Artificial Island Proposal Window

PJM Special TEAC
Artificial Island Review
05/19/2014
Version 2

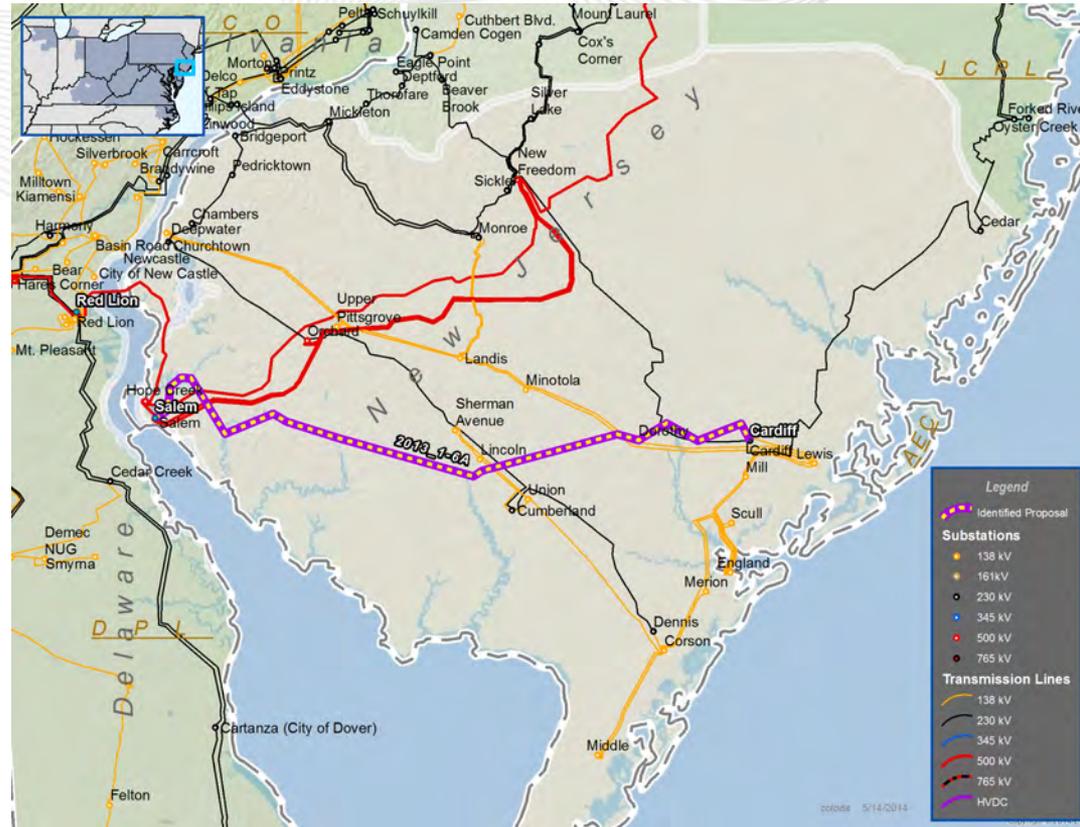
- HVDC line between Artificial Island and Cardiff
- SVC at Artificial Island converter station
- Estimated costs higher than other proposals

- **Stability Performance**

- Failed required performance

- Failed as proposed by project sponsor.
- Did not satisfy stability criteria for a SLG fault with stuck breaker with AI units at unity power factor under 5015 maintenance outage condition without significant MW flow on the proposed HVDC facility from the AI to Cardiff.

Transource (AEP) 2A
Salem Expansion

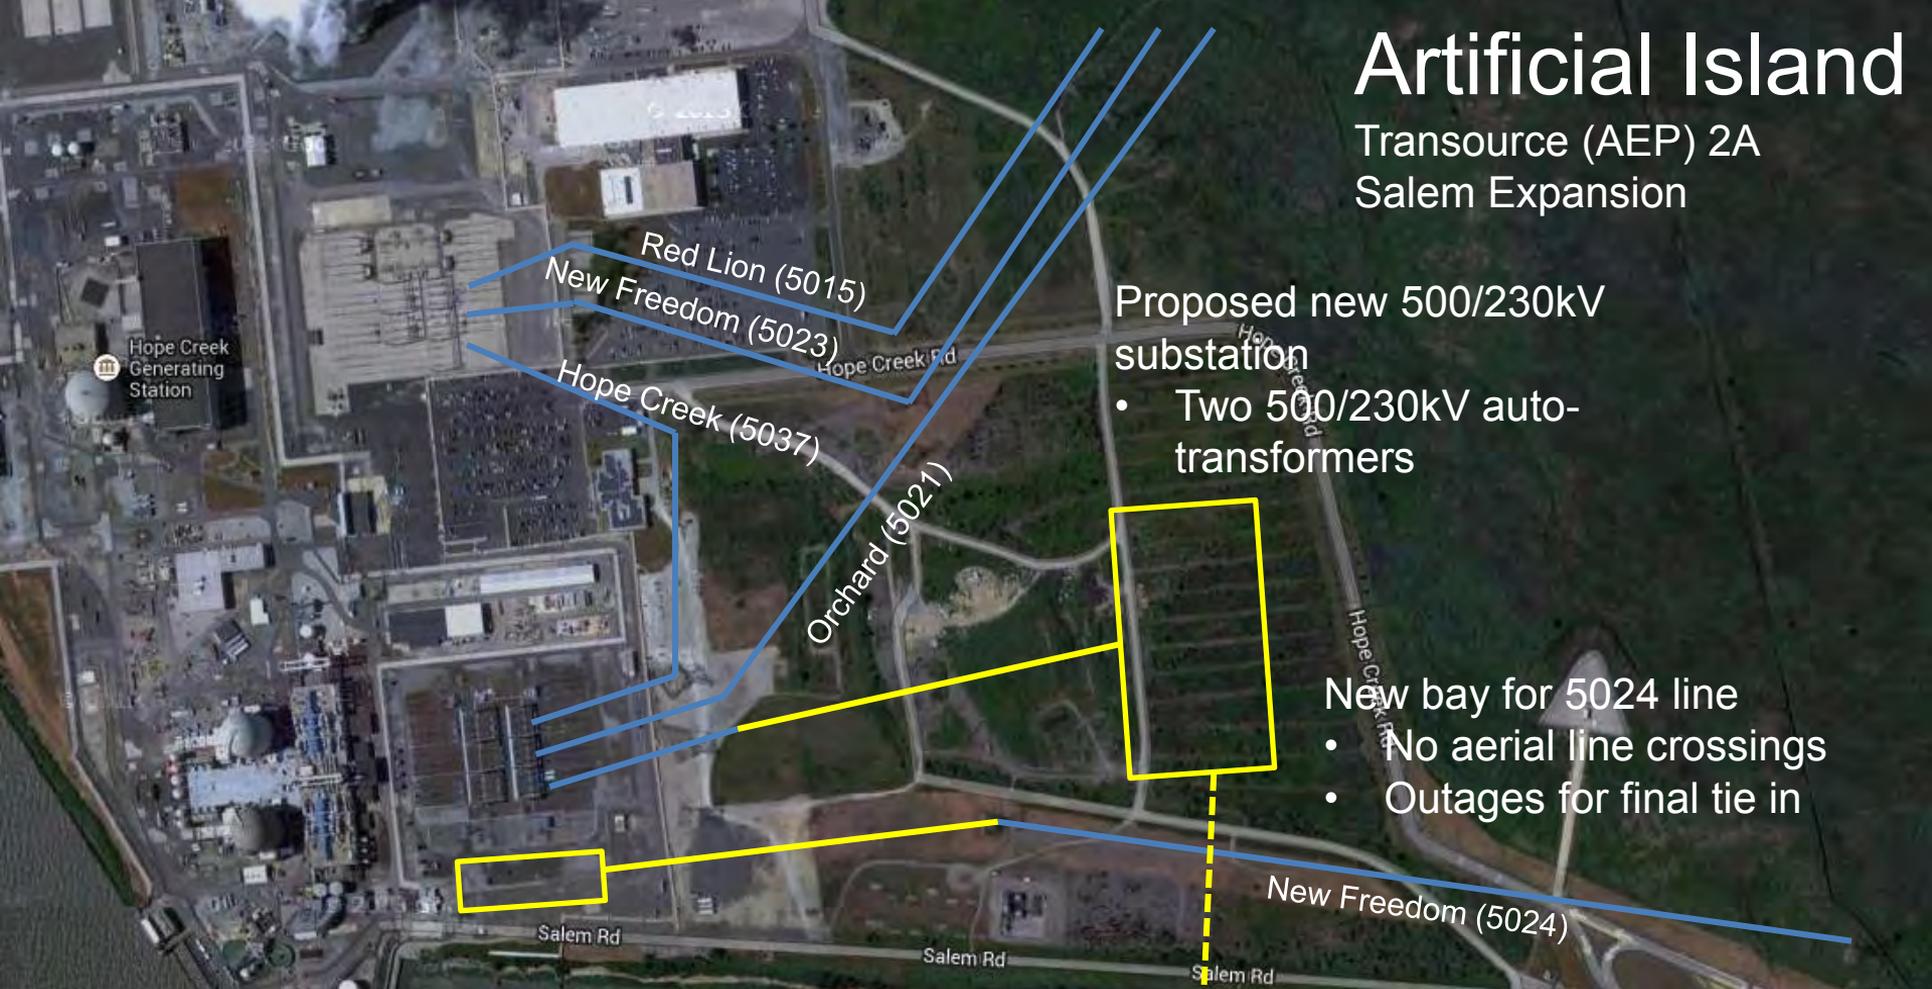
- **Stability Performance**

- Failed required performance

- Failed as proposed by project sponsor
 - Did not satisfy stability criteria for a single line to ground fault with stuck breaker with AI units at unity power factor under 5015 maintenance outage condition.

- Passed required performance

- Passed when modified with the addition of an SVC at Orchard, New Freedom or Artificial Island

LS Power (Submarine) 5A

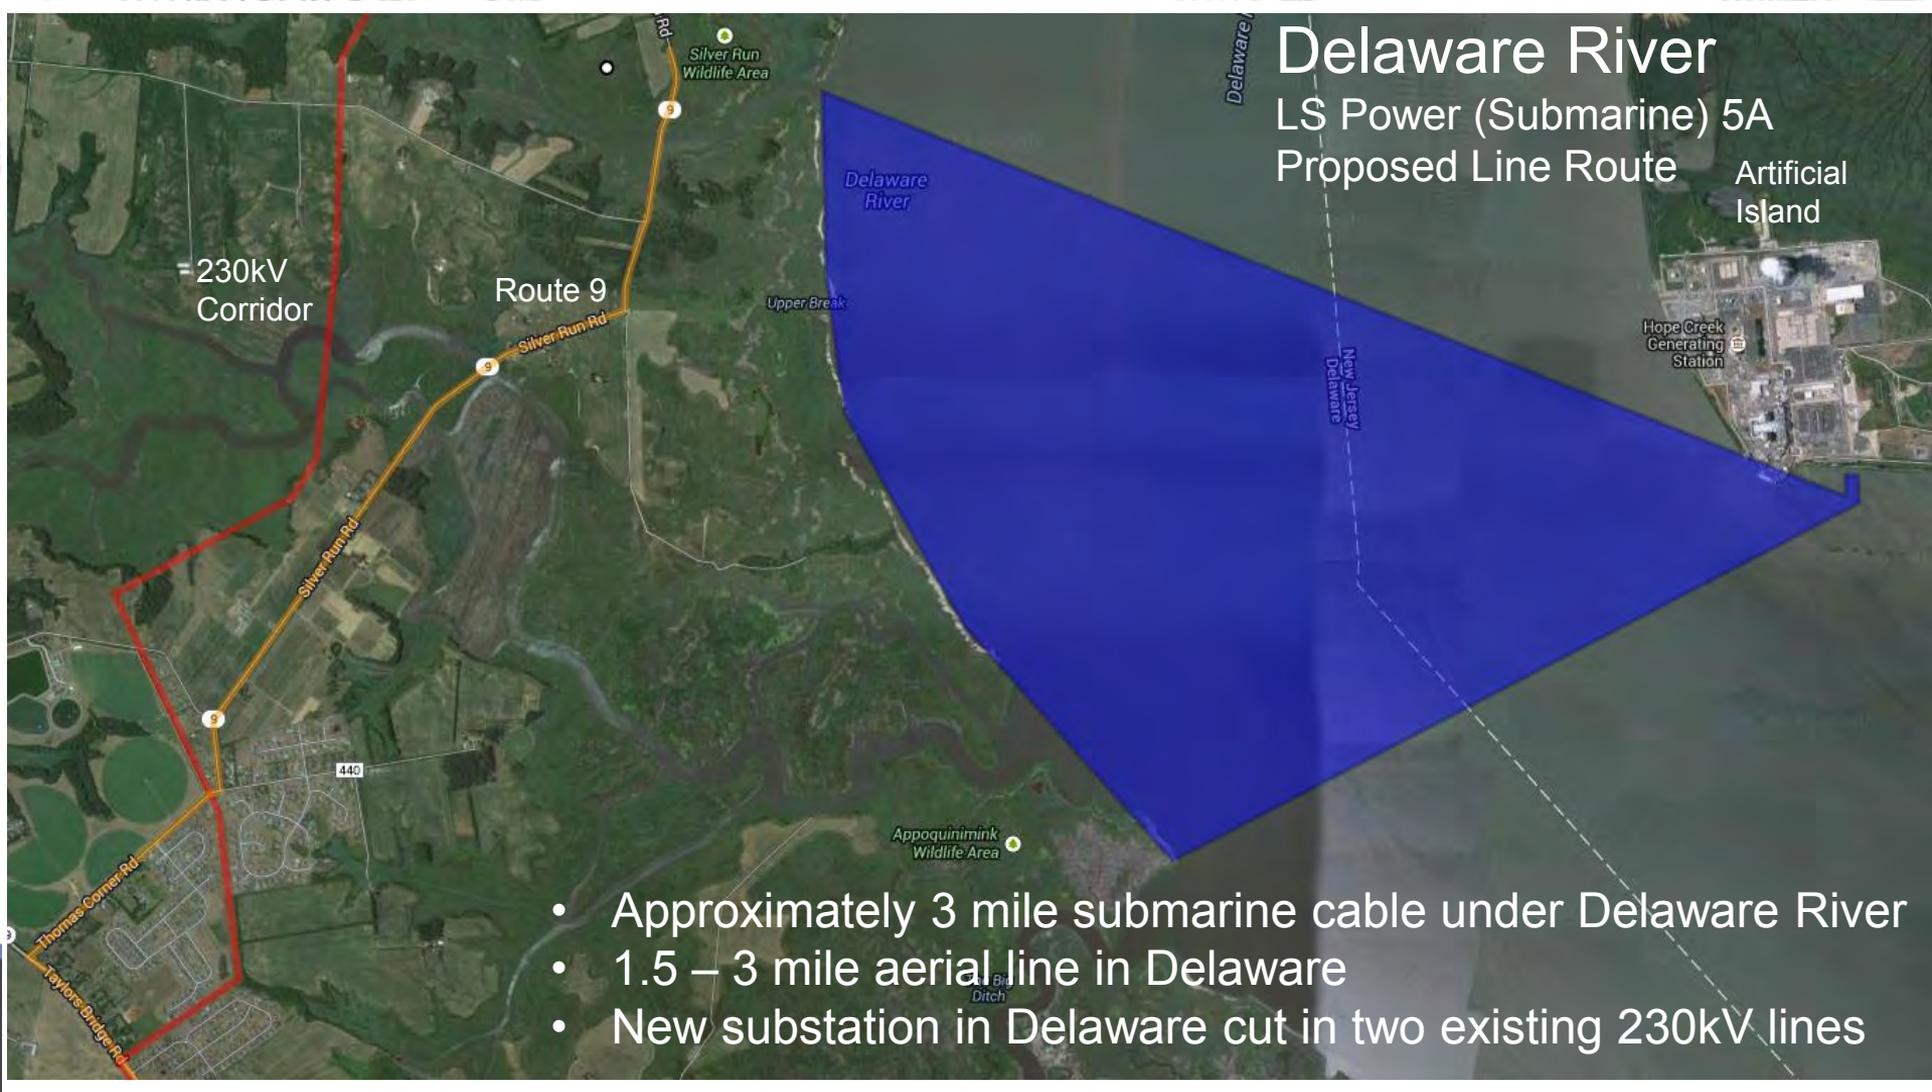
- **Stability Performance**

- Failed required performance

- Failed as proposed by project sponsor.
- Did not satisfy stability criteria for a three phase fault with AI units at unity power factor under 5015 maintenance outage condition.

- Passed required performance

- Passed as proposed with the addition of an SVC at Orchard, New Freedom or Artificial Island

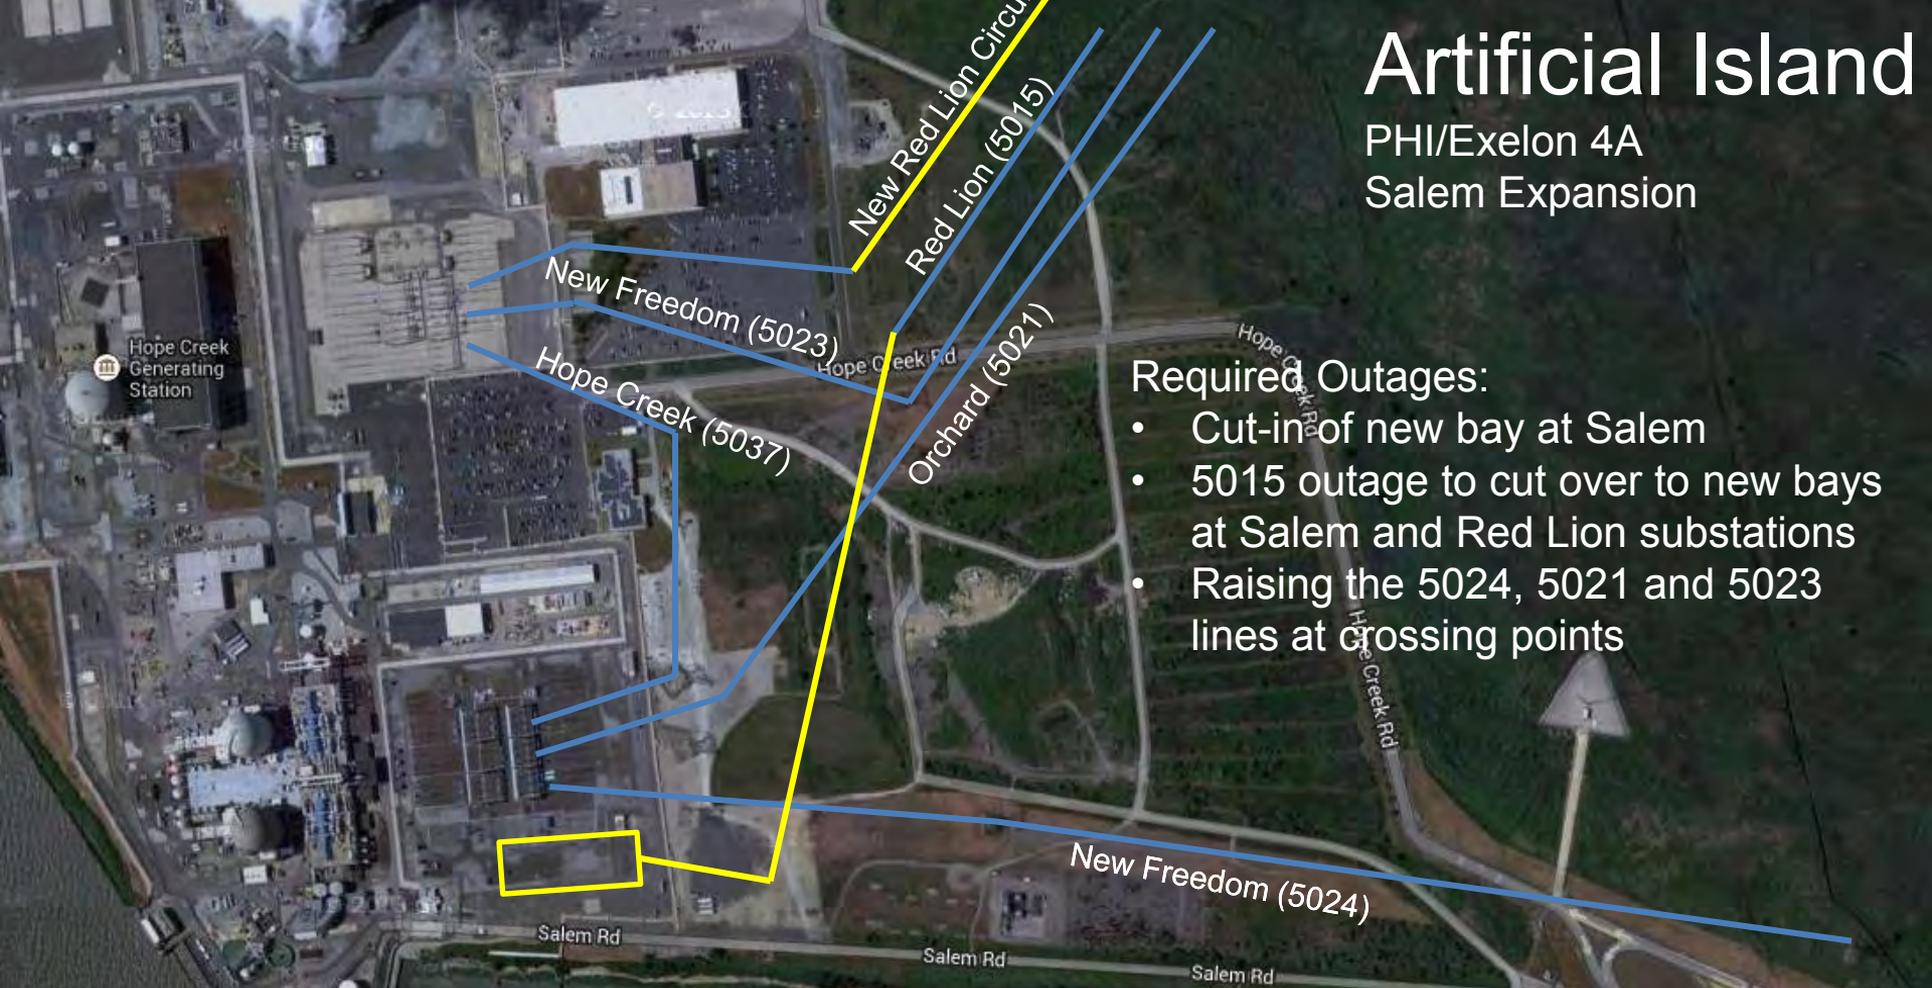
- New 500kV Line between Salem and Red Lion substations
- PJM modifications
 - Technical:
 - Analysis based on building only the Salem to Red Lion segment of proposed Salem to Peach Bottom proposal
 - Added SVC
 - Constructability:
 - Dead-end towers added around line crossing
 - New Salem connection as a full bay

- **Stability Performance**

- Failed required performance

- Failed as proposed by project sponsor.
 - Failed with modification to change connection point at Salem to bus bar #1 from #2.
 - Did not satisfy stability criteria for a single line to ground fault with stuck breaker with AI units at unity power factor under 5015 maintenance outage condition.
 - Did not satisfy stability criteria for a single line to ground fault with stuck breaker with AI units at unity power factor under 5015 maintenance outage condition with modification to change connection point at Salem to bus bar #1 from #2.

- Passed required performance

- Passed as modified with the addition of an SVC at Orchard, New Freedom or Artificial Island.
